AGENDA
HISTORIC PRESERVATION BOARD
LAKELAND ELECTRIC, CONFERENCE ROOMS 1A & 1B
June 27, 2024, 2024 8:30 A.M.

AGENDA
DESIGN REVIEW COMMITTEE
LAKELAND ELECTRIC CONFERENCE ROOMS 1A & 1B
June 27, 2024
immediately following the Historic Preservation Board Meeting

- IV. Consideration of Certificate of Review Applications:
 - A. Oath Administration for Public Testimony by Assistant City Attorney.
 - B. [HPB24-116 – 207 E. Main Street](#) – Final Approval for the installation of an illuminated projecting sign on the building wall at the subject address. Owner: TR Hillsborough LLC. Applicant: Dixie Signs Inc.

D/F Projecting Building Sign
 Scale: 1" = 1'-0"

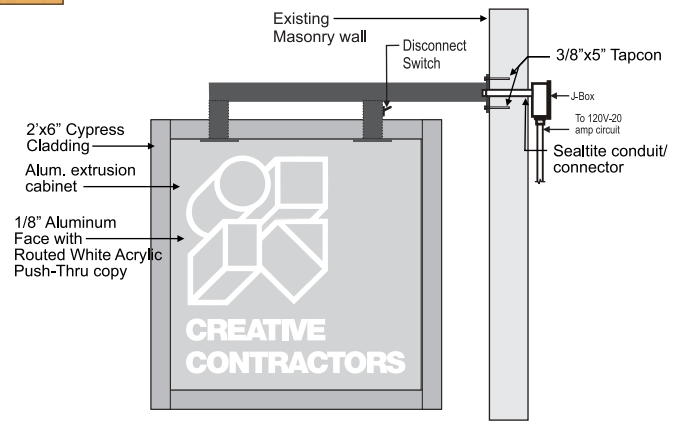
Staff finds that the design, size, and internal illumination of the requested sign as presented by the Applicant meets the Sign Guidelines and Standards and is not determined to be cabinet signage due to only the logo and text being lighted.

N
Site Plan - Scheme A-3
SCALE: 1" = 30'-0"

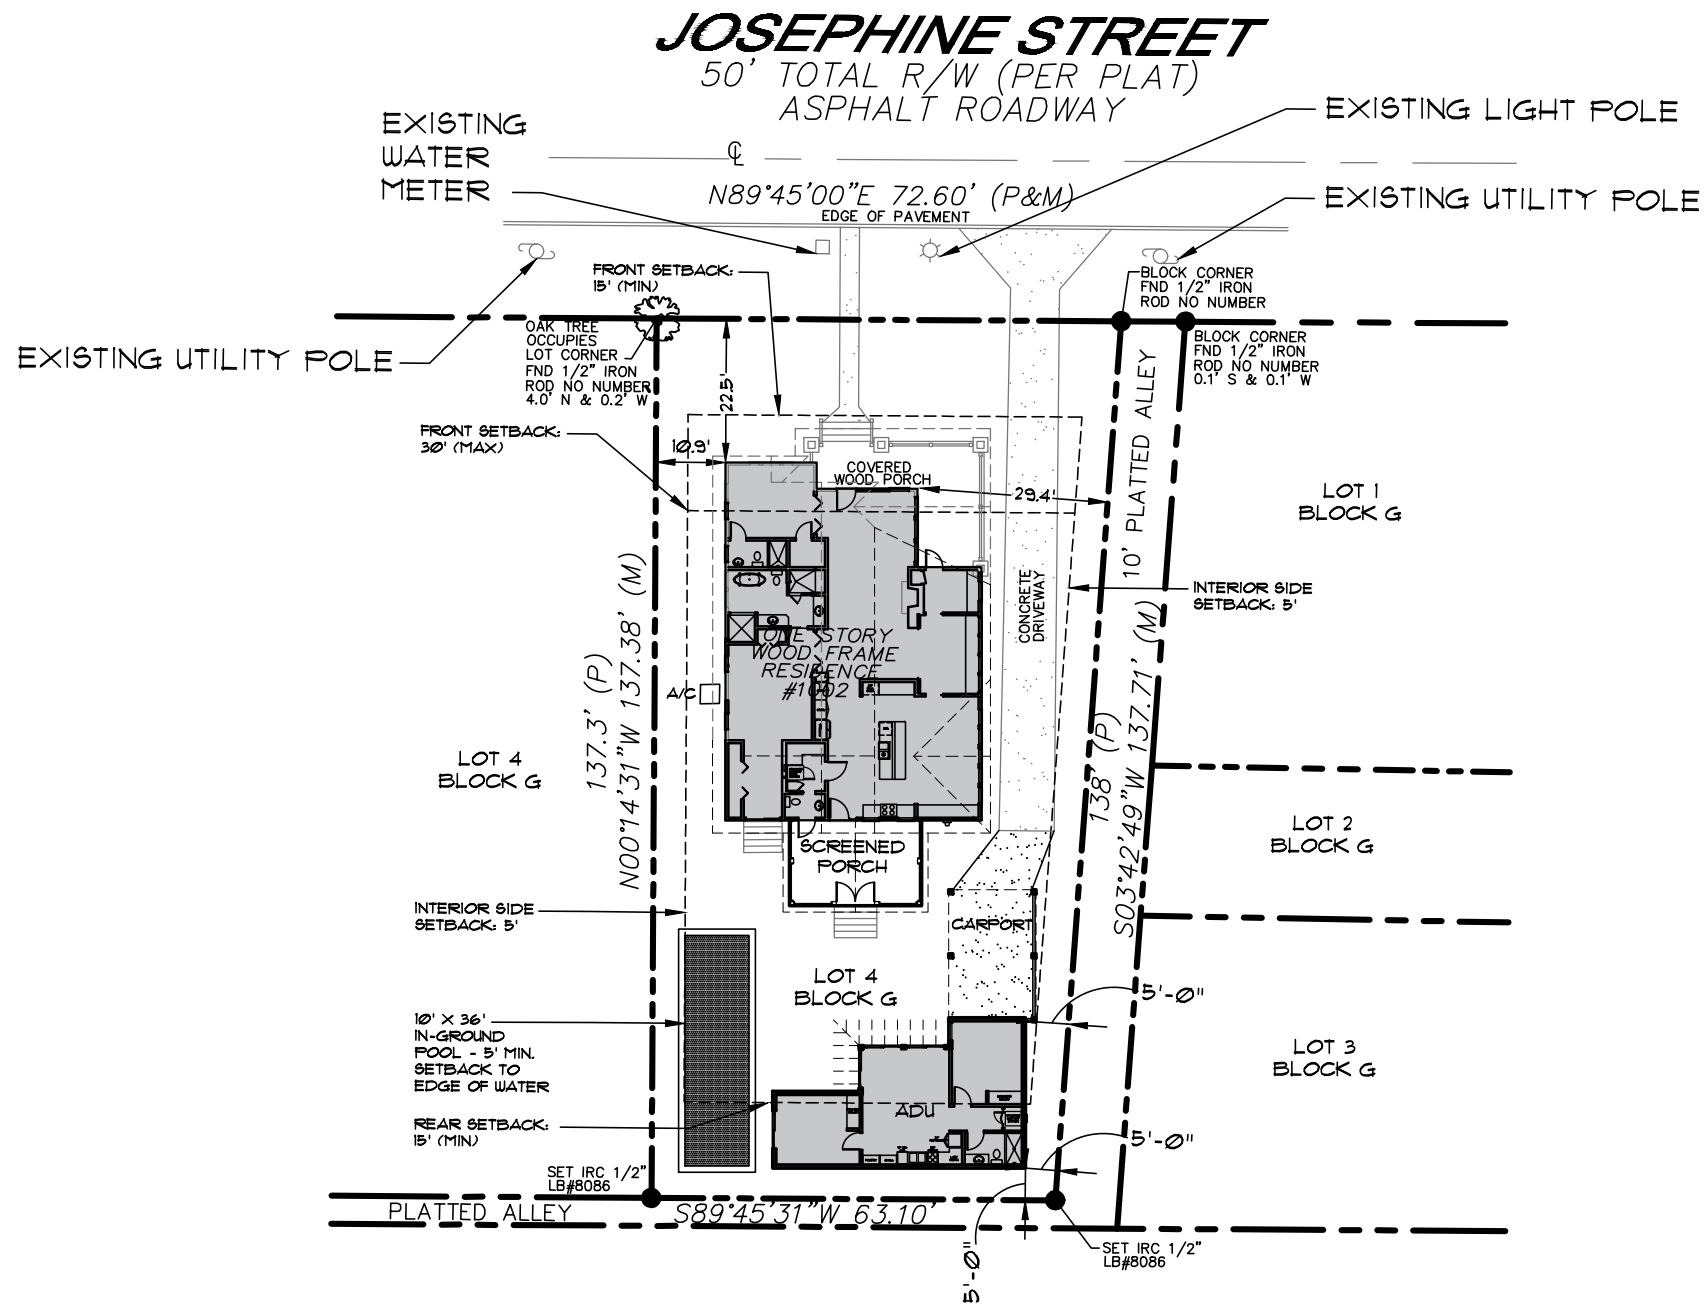
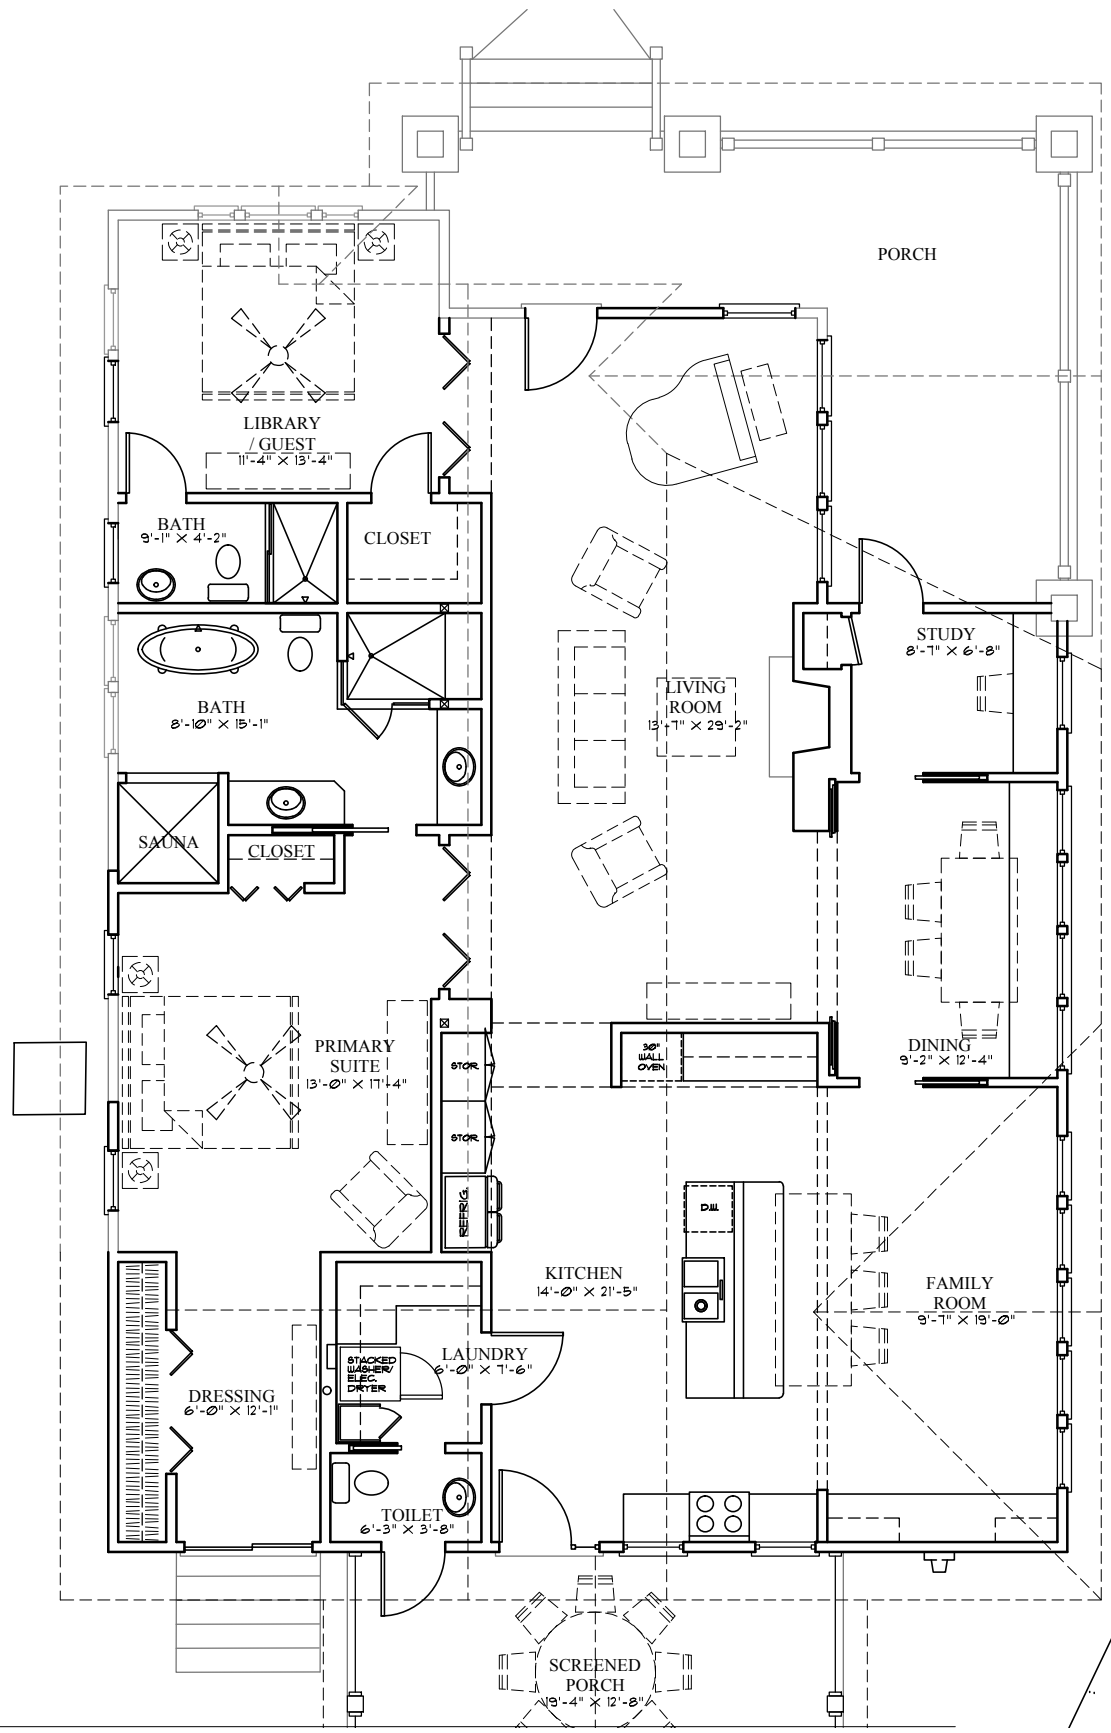
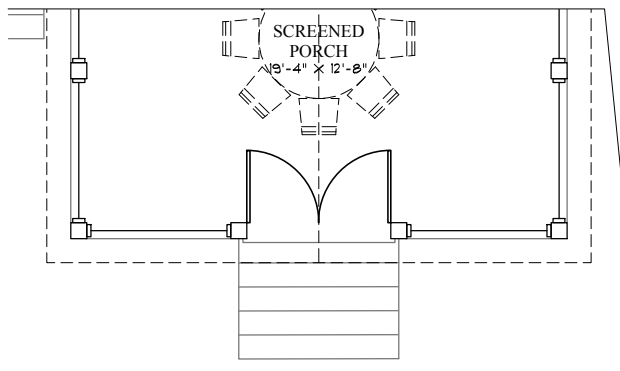
The site plan submitted for these requests shows that the addition to the house complies with the minimum interior side and rear building setbacks required by the Land Development Code. The proposed setbacks for the ADU at 5 feet from the side and rear property lines also comply with the minimum building setbacks required by the Land Development Code, and the overall square footage of the ADU is within the maximum allowed by the Land Development Code.

1. Windows must be installed with a recess into the wall plane to provide a shadowline, consistent with the appearance of historic wood window openings.
